TO: ALL HOLDERS OF ELEVATOR CONTROL FEEL AND CENTERING TUBE AND CRANK ASSEMBLY
OVERHAUL MANUAL 27-37-13

REVISION NO. 5, DATED JUN 5/88

HIGHLIGHTS

27-37-13

Elevator Control Feel and Centering Tube and Crank Assembly
Figure 4

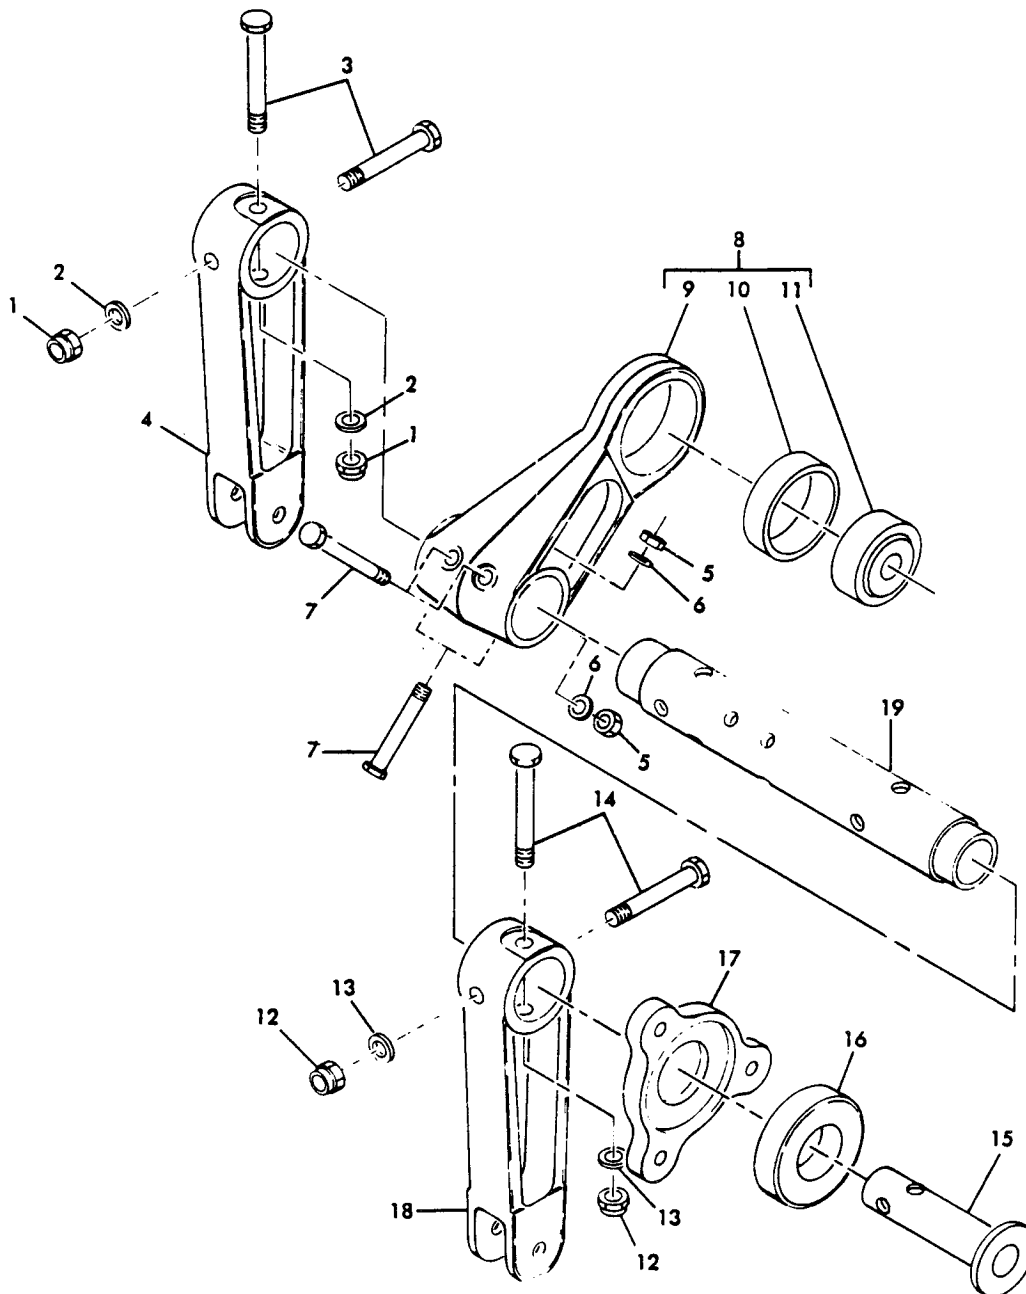
DESCRIPTION OF CHANGE	TOPICS AFFECTED												
	D & O	D / Assy	Cleaning	Insp / Chk	Repair	Assy	F / C	Test	T / Shooting	S / Tools	Storage	IPL	L / Overhaul
Changed crank assembly refinish to ease manufacturing					X

- (2) Crank assembly (9) -- Apply colored chemical coating (F-17.10). Apply one layer of BMS 10-11, type 1 primer (F-20.02) all over, except do not apply primer to the 1.093 and 1.5625 inch diameter holes. Material: Al alloy.
